Watercourse flooding

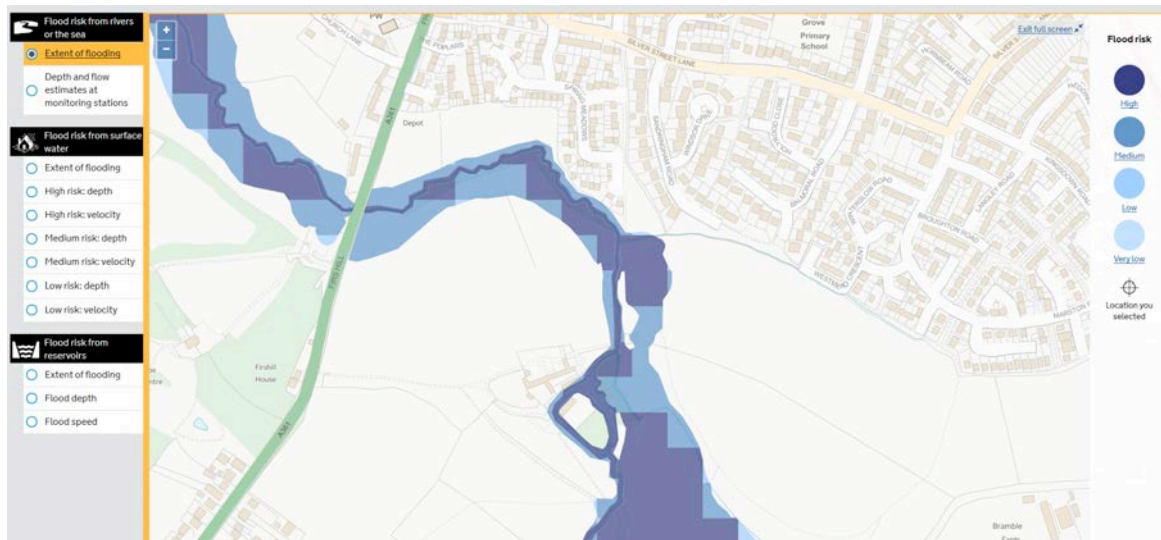
The charts clearly show significant effects, with the acknowledged potential of flood flow onto the site from the current built form, an effect which has not been addressed in any plan or statement.

Water flow projections

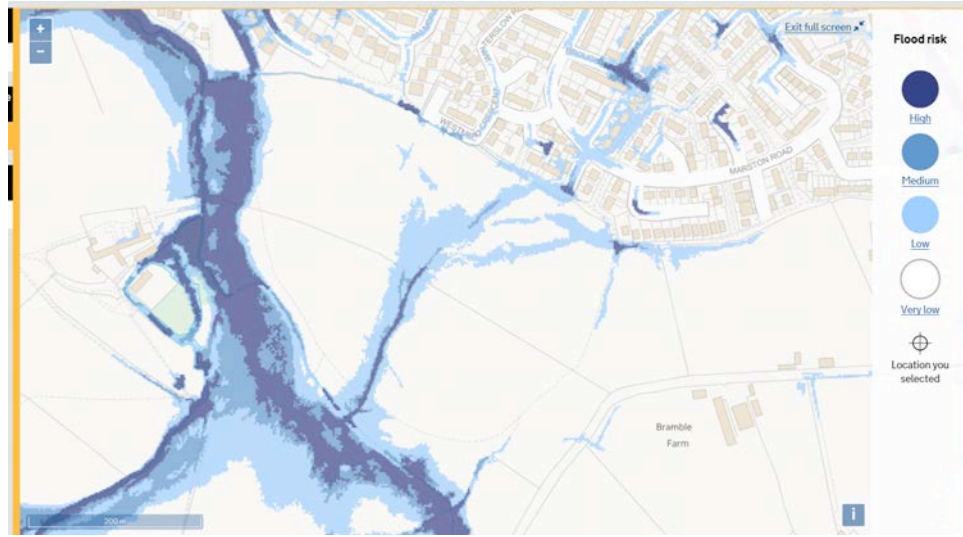
This projection speaks crucially to the issue of source of surface water flow as potential inundation is clearly shown to be from both North and South where surface water drains currently empty in to both ditch and watercourse.

Combined flood zones

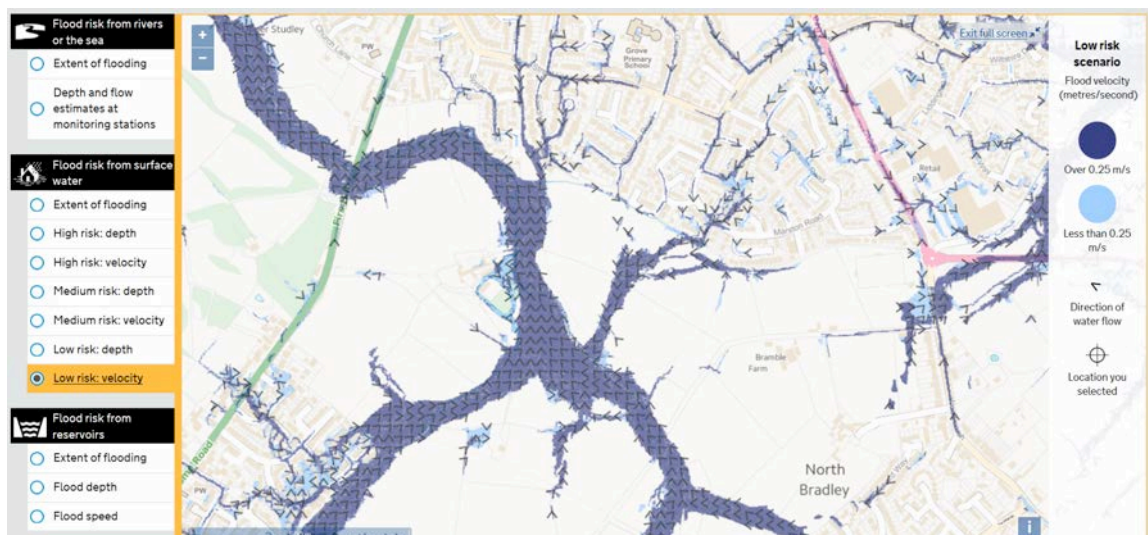
Clearly the issue of surface water cannot have been addressed as flooding currently takes place at the foot of the slope, and the addition of 180 homes with foot and vehicular access can only exacerbate this without a dedicated solution at the foot of the slope. This area regularly floods and impacts on current dwellings as has been shown in submitted photographic evidence (ref. my initial submission to the Inspector and to the Consultation). Positioning such attenuation would necessitate the re-routing of a 46cm ductile iron water main, since the main itself has a legislated 6m permanent access required on either side. (Water main map in appendix)
